Recall Campaign Bulletin

Campaign No. 2024010011, February 2024

SUBJECT: **Model Various Models**
Model Year 2021-2024

Replace Fuel Pump Delivery Module Wave 1

Figure 2

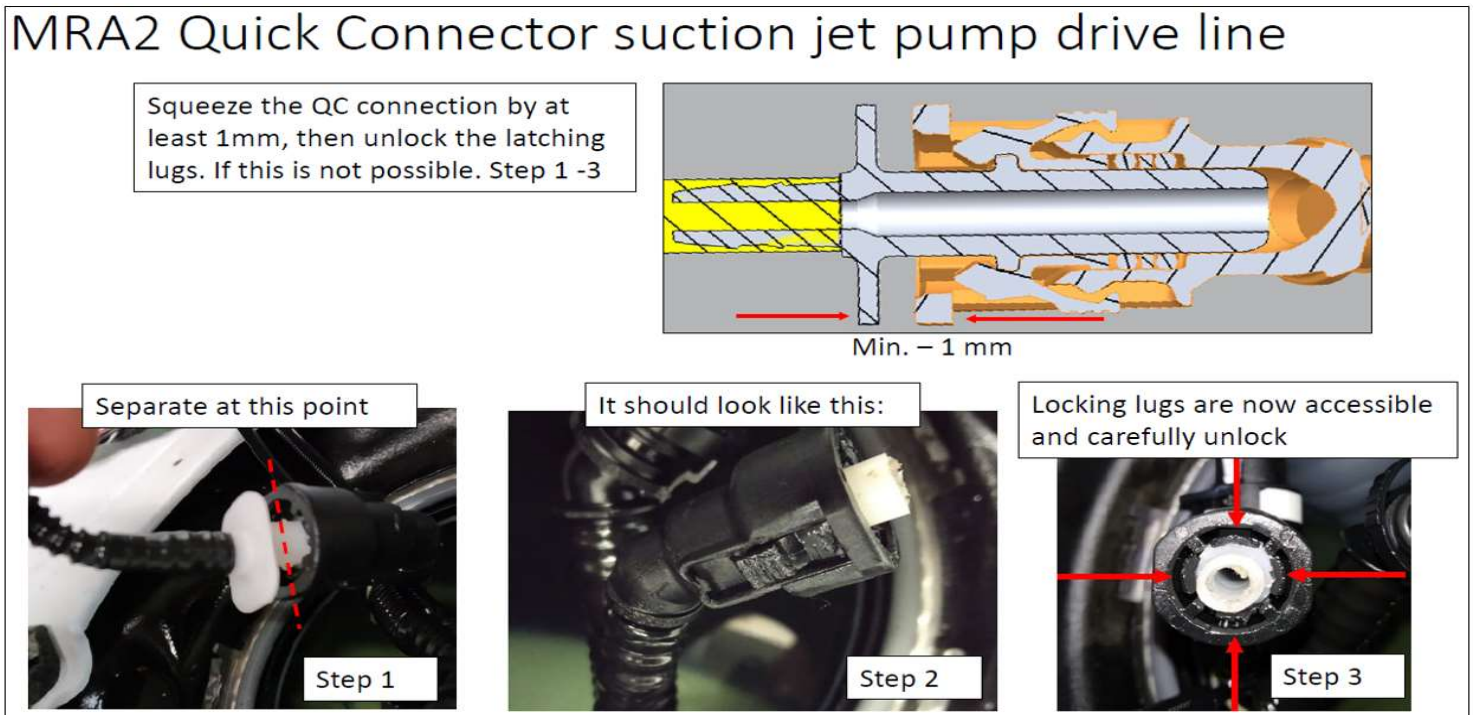
i **Only model 206, 232:** Note on disassembly of suction jet pump drive line quick connector.

The procedure steps 1-3 should only be performed when the quick disconnect is not working (**Figure 2**).

Figure 4 (remove electric lines from routing clip)

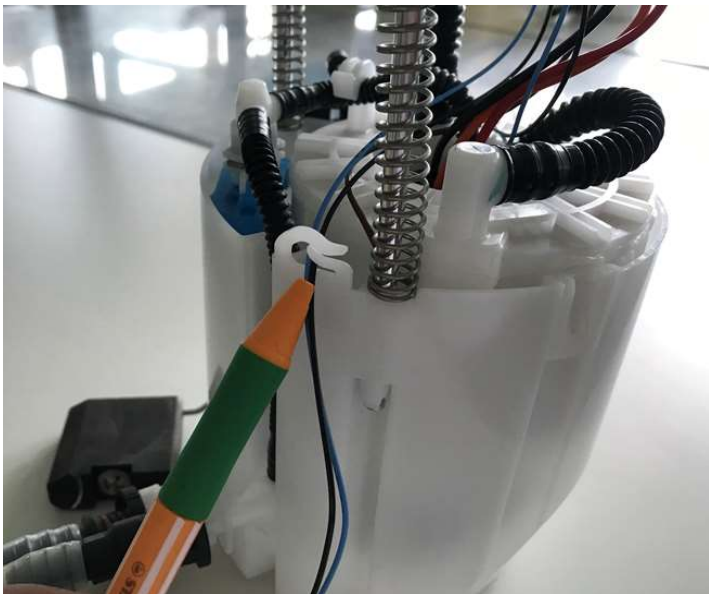
i Delivery modules that are delivered **without float-and-lever sensor** must be modified. (**Figure 4-7**)
